Replace Rear Door Lower Edge Protectors

Classification Repair Bulletin **Section/Group** 11 - Closures **Country/Region** All

Year 2016-2017 **Model** Model X **Version** All

This Service Document supersedes SB-17-11-003, dated 6-Nov-17. Each content change is marked by a vertical line in the left margin. Discard the previous version and replace it with this one.

Figure 1 (Cutout for drain hole)

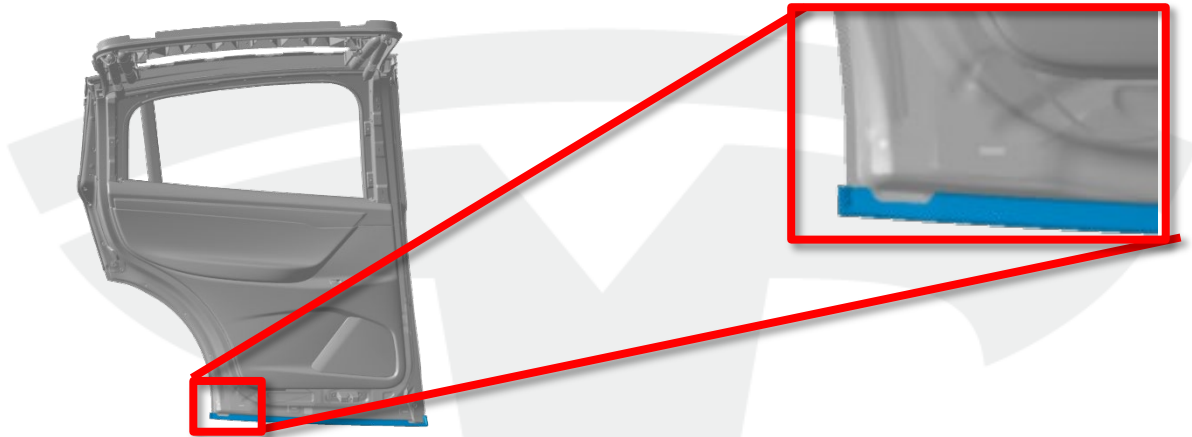
1. Inspect the lower edge protector :
 - If the rear of the rear door lower edge protector has a cutout for the drain hole in the door shell (Figure 1), no work is required. Discontinue this procedure.
 - If the rear of the rear door lower edge protector does not have a cutout for the drain hole in the door shell, continue to the next step.

Upon customer complaint of rear doors not functioning in freezing temperatures, install improved rear door lower edge protectors to increase water egress out of the rear lower doors.

Figure 2

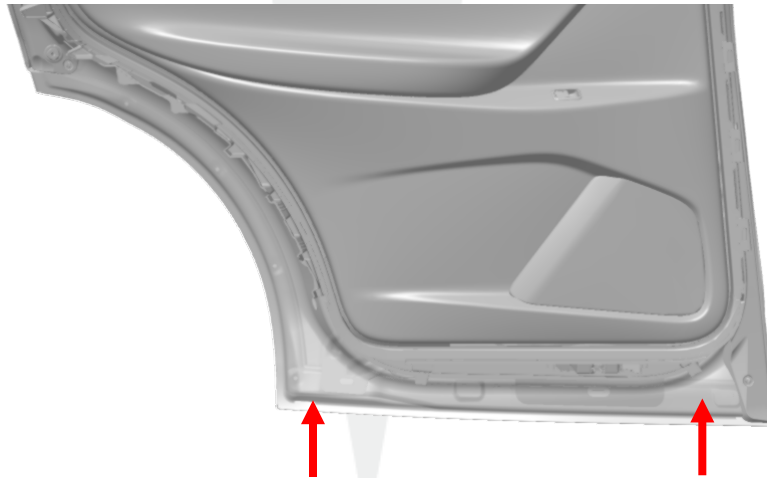
2. Remove the rear door lower edge protector.
3. Remove any debris that obstructs the drain holes in the door shell (Figure 2).
